**PRELIMINARY OVERALL
 AREA DEVELOPMENT PLAN**
**SOUTHSIDE I. S. D.
 LOOP 1604 FACILITIES**

Re: Southside ISD Loop 1604 Facilities

POADP # 610

The City Staff Development Review Committee has reviewed Southside ISD Loop 1604 Facilities Subdivision Preliminary Overall Area Development Plan # 610. Please find enclosed a signed copy for your files. Although your plan was accepted, please note the following:

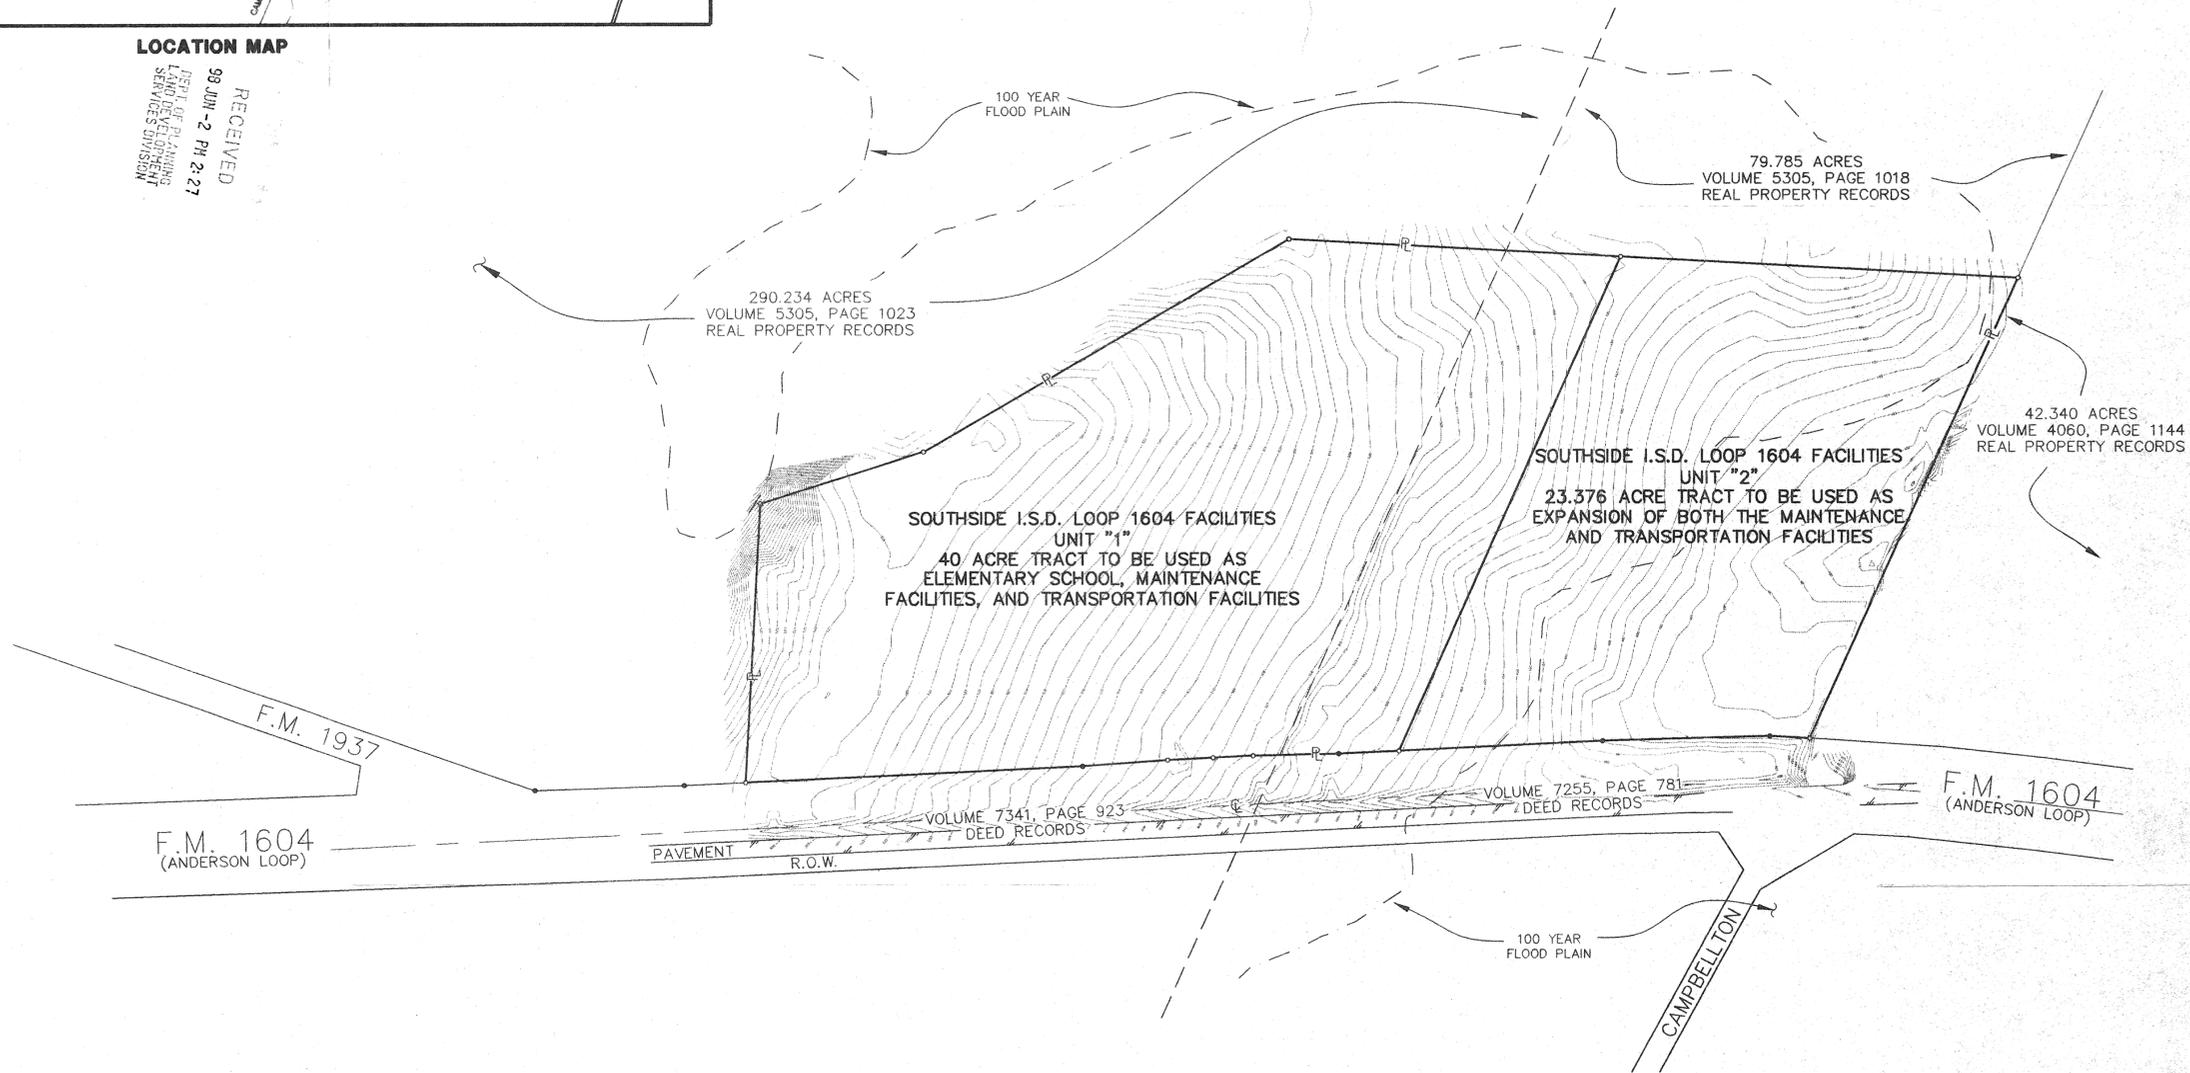
- Based on the topography, a Flood Plain Study and drainage review will probably be required during the platting process.
- Access and R.O.W. issues along State facilities will need to be resolved with the Texas Department of Transportation (TXDOT). For information about these requirements you can contact TXDOT at 615-5814.
- This development will need to comply with tree preservation ordinance #85262. For information about these requirements you can contact Building Inspections at 207-7102.
- It will be expected that you will plat all of the property depicted in your POADP, to include: floodpains, drainage areas and open space.
- I would encourage you to work closely with the school district, so that they can plan accordingly.
